ADDENDUM NO. 2

CLARIFICATION NO. 2

LANDSCOPE (MAURITIUS) LTD
INFRASTRUCTURE WORKS FOR EDUCATION AND HEALTH HUB AT COTE D'OR
REF No.: LM/CD/OC23/35

23125-TD-3TP702

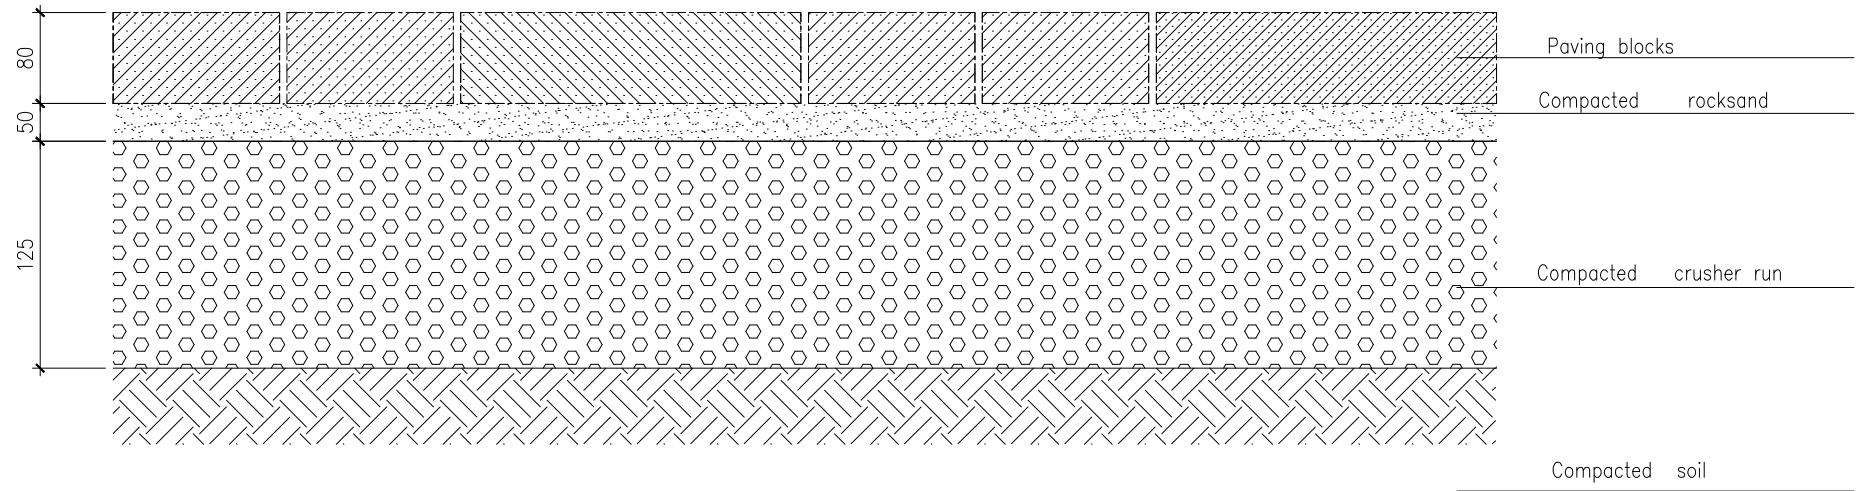
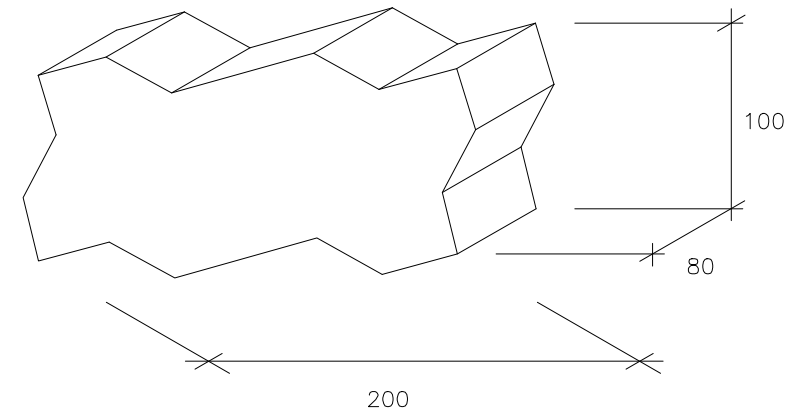
4.	In which BOQ item should we price the precast slab 600x300 for the walkway & seating	Precast concrete slab 600x300 and heavy-duty paving blocks for the pedestrian walkway shall be priced under Item 609. It is hereby brought to the attention of bidders that Pages 100 and 246 of Volume 1 of 4 of the Bidding Documents have been replaced by Pages 100 and 246 with labelling “Addendum No. 2”. It is hereby brought to the attention of bidders that Drawing 23125-TD-3TP702 of Volume 3 of 4 of the Bidding Documents has been replaced by Drawing 23125-TD-3TP702 with labelling “Addendum No. 2”. The aforementioned changes to the bidding documents have been enclosed in Annex B .

15.	<p>Drawing No. 23125-TD-3TP101 We find that there are 600 x 300 mm precast slabs on the surface of the walkway & seating. However, this has not been catered in the BOQ. Please advise.</p>	<p>Refer to Reply to Query No. 4</p>

n) HEAVY DUTY PAVING BLOCKS AS PER DRAWINGS (80mm thick) AND PRECAST CONCRETE SLAB (60mm thick)

- Supply of all materials and plants.
- Excavation to the required level.
- Cleaning shaping and trimming of subgrade.
- Supply, level and compact 60mm of rocksand including vibration for filling of joints with rocksand or mortar.
- Supply, transport and laying of precast paving blocks as per Engineer's Drawings.
- Supply, transport and laying of precast concrete slabs (600x300 and 60mm thick) with chamfered edges as approved by the Engineer
- Lightly rough finish to surface as approved by Engineer.
- Filling of joint with rocksand including vibration.
- Any miscellaneous costs arising.

Drawing number
23125-TD-1BR03

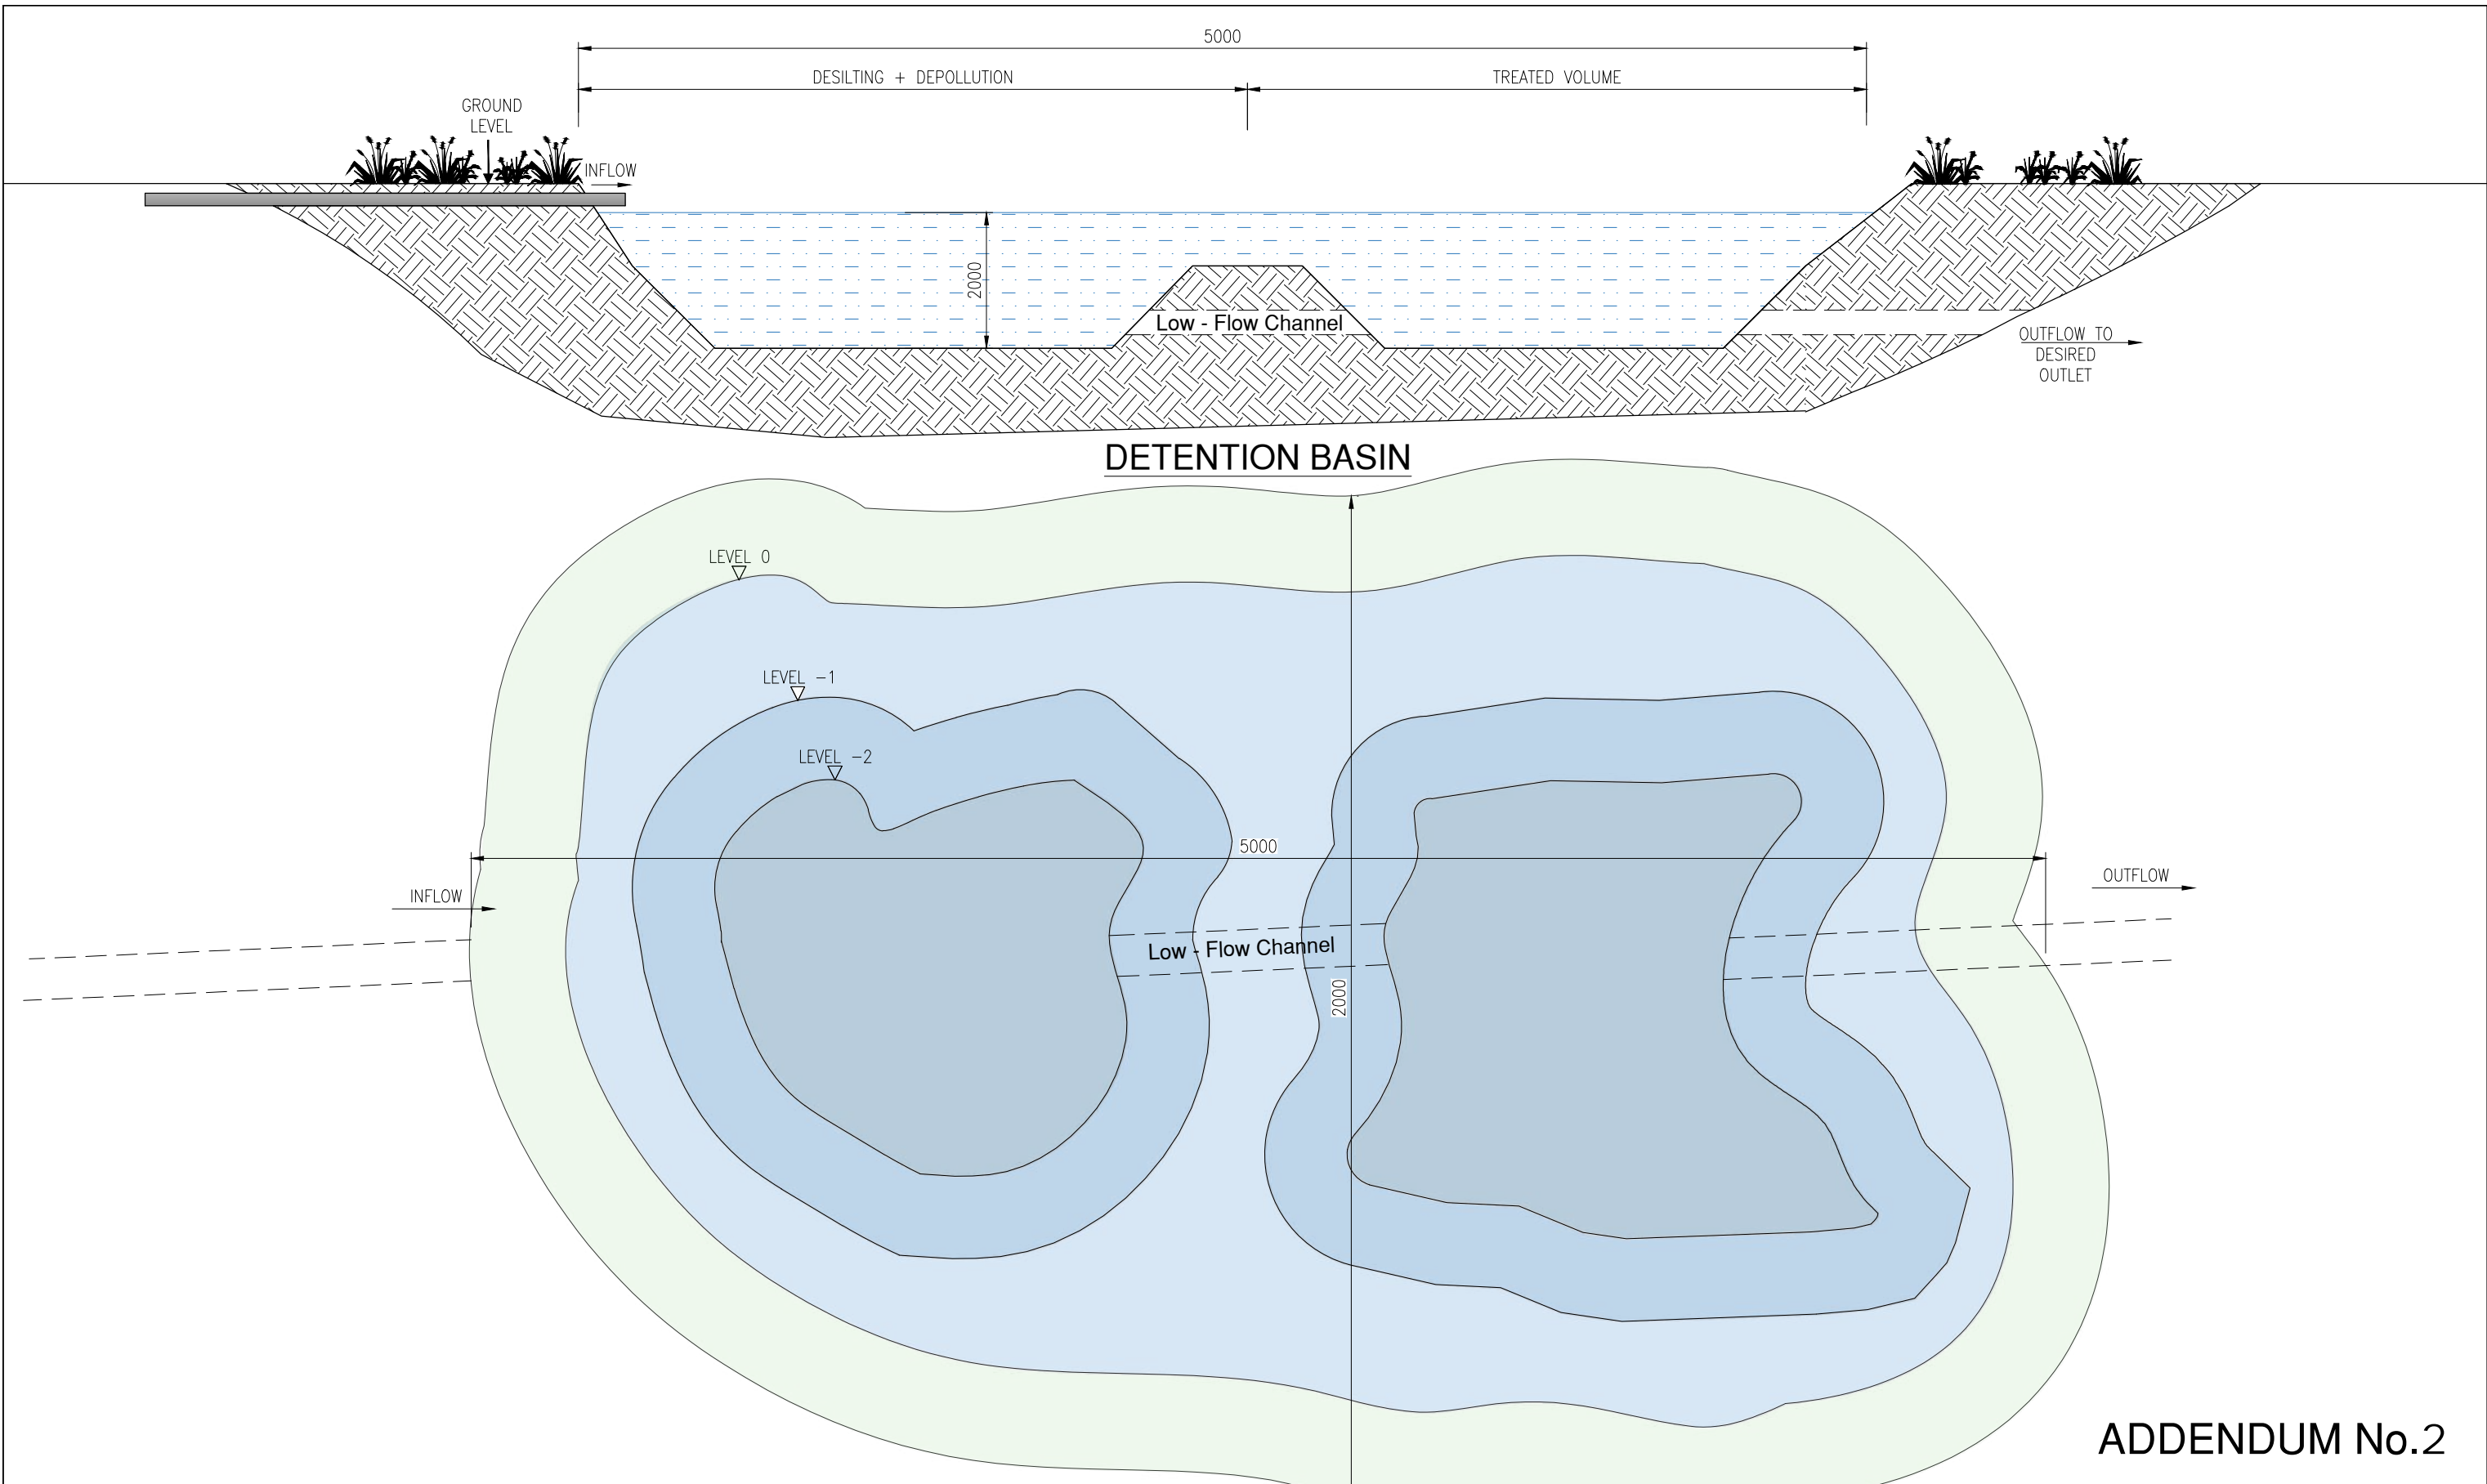
17.	<p>Lot 1 Bill Item 601H Provide dimension and detail of drain</p>	<p>It is hereby brought to the attention of bidders that 23125-TD-1BR03 of Volume 3 of 4 has been replaced by 23125-TD-1BR03 marked as "Addendum No. 2" as attached in Annex E.</p>

23125-TD-3TP214

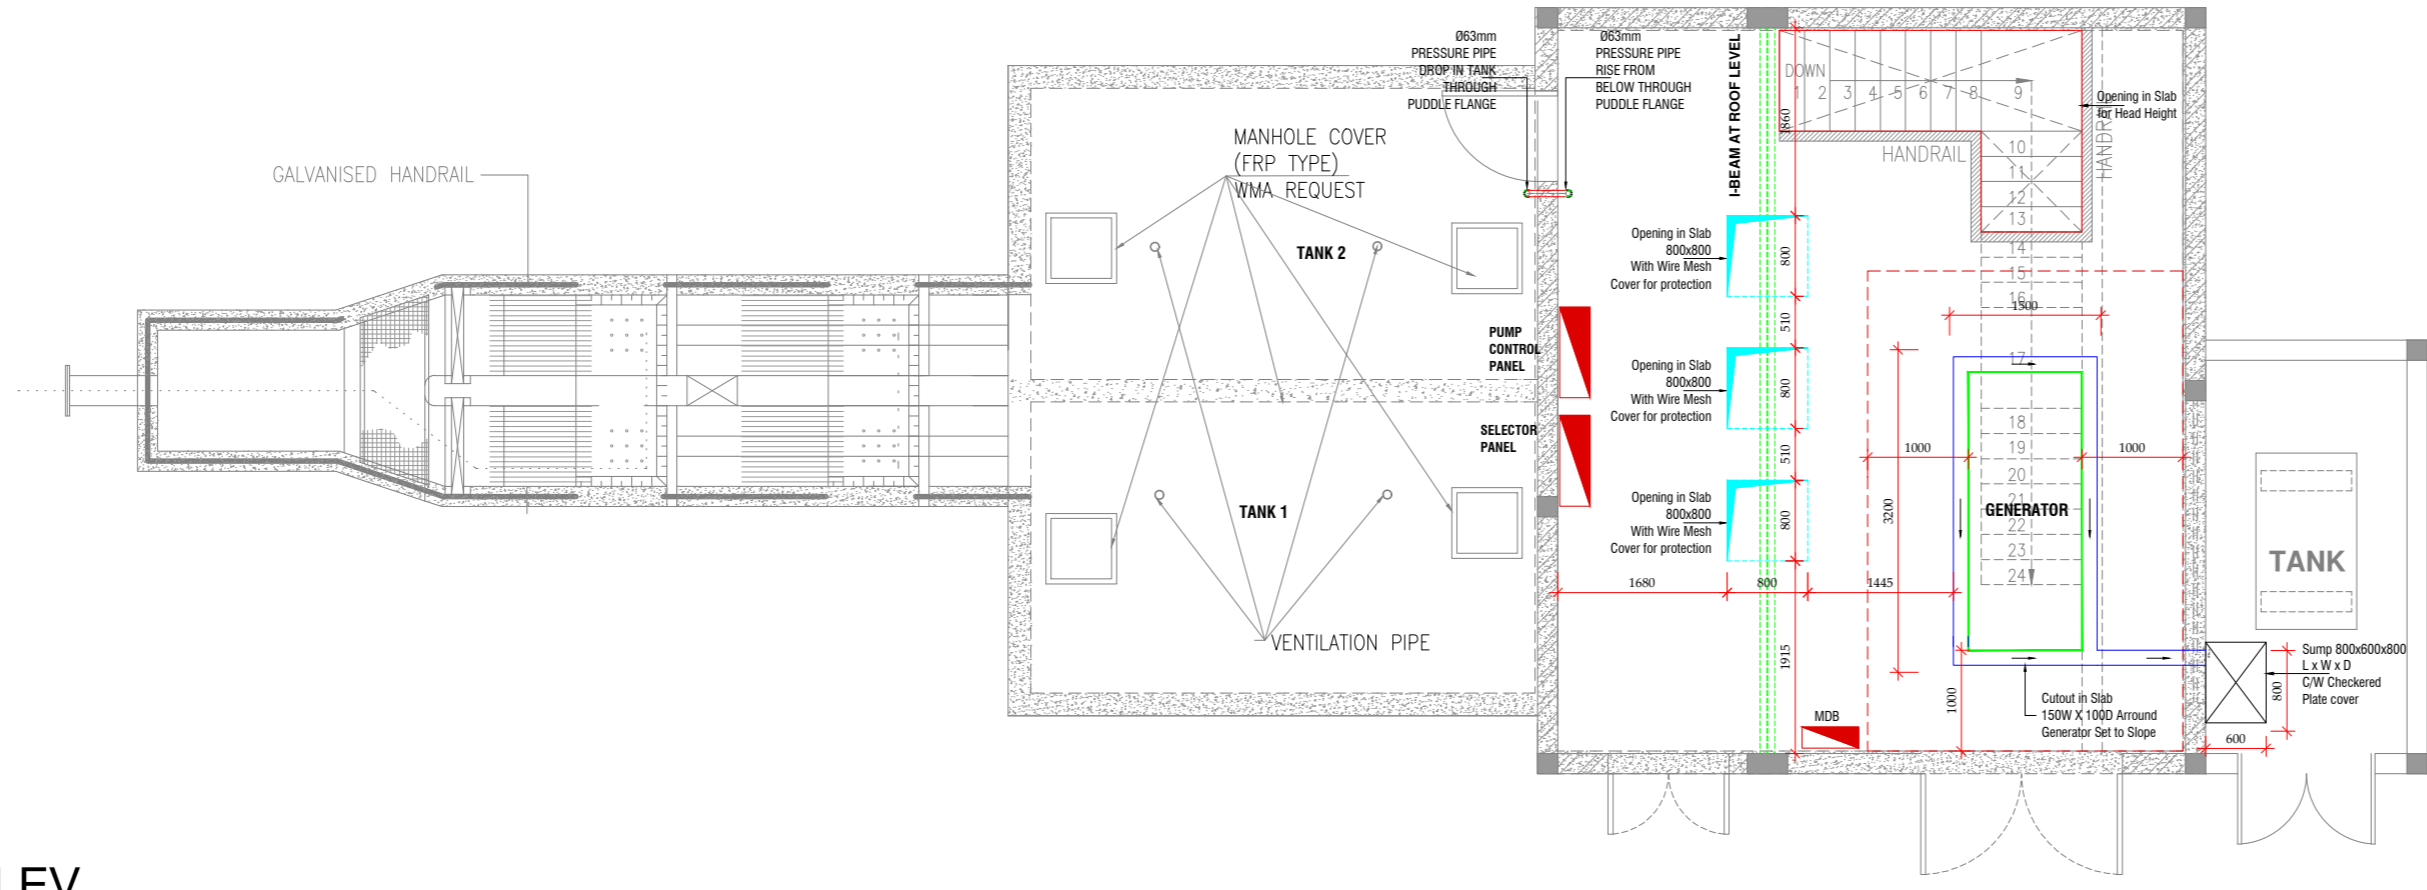
SN	ORIGINAL QUERIES BY BIDDERS	REPLY FROM EMPLOYER
18.	Lot 1 Bill Item 606A Provide drawing with dimensions	It is hereby brought to the attention of bidders that 23125-TD-3TP214 of Volume 3 of 4 has been replaced by 23125-TD-3TP214 marked as “Addendum No. 2” as attached in Annex F

33.	Item 606A: Desiltation Basin: We note that specific dimensions have not been provided in the tender drawings. Please provide same as well as the actual excavation volume with respect to the topography and L-profile at the location of the basin	Refer to Reply to Query No. 18
